Arlington Zoning Board of Appeals

Date: Tuesday, September 8, 2020

Agenda Items

RE: Docket 3594 – 72-74 Grafton Street; Special Permit under Zoning Bylaw Section 8.1.3

THIRD FLOOR PROPOSED PLAN - NEW DORMER A1

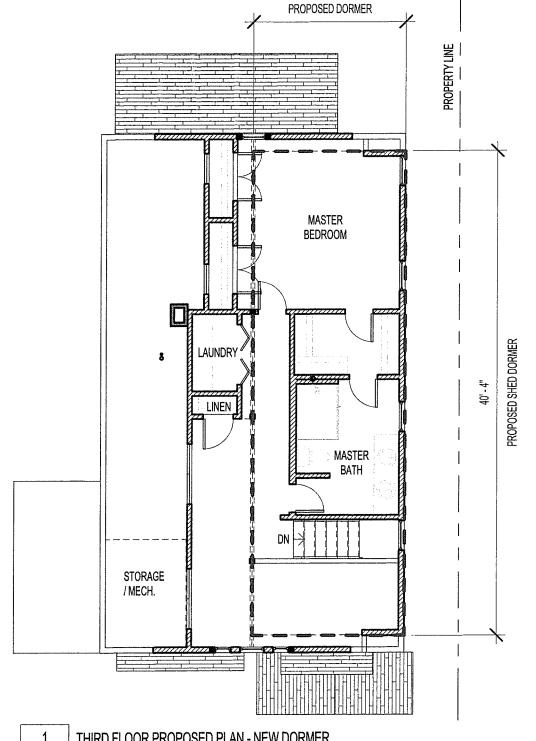
The applicant, Matthew Boland, seeks a Special Permit in accordance with Section 8.1.3 (B) (Nonconforming Single-Family or Two-Family Dwellings) of the Zoning Bylaw. The applicant seeks to construct an addition of a dormer on the upper level of their living unit in a two-family structure. The addition would increase the total square footage of the structure from 3,766 to 4,008 square feet (+242 square feet). It is unclear whether the proposed addition meets the definition of a half story, as the applicant has not provided dimensional details showing the total area of the finished floor below the roof framing and slope of the roof that will be at a height of seven feet or more.

The requested use is permitted in the R2 Zoning District through the granting of a Special Permit if less than one half the floor area measured from the underside of the roof framing to the finished floor below has a clear height of 7 feet 0 inches or more. The applicant has not provided the necessary dimensions to calculate whether the proposal complies with this definition.

The applicant has not provided floor plans of the existing conditions on the third floor. However, it appears that this proposal would provide additional living space through the addition or renovation of a bedroom, bathroom, and laundry area.

The Department of Planning and Community Development recommends that the Zoning Board of Appeals requests details regarding the dimensions of the third story of the structure to ensure that the addition meets the Zoning Bylaw's definition of a half story prior to approving this application.
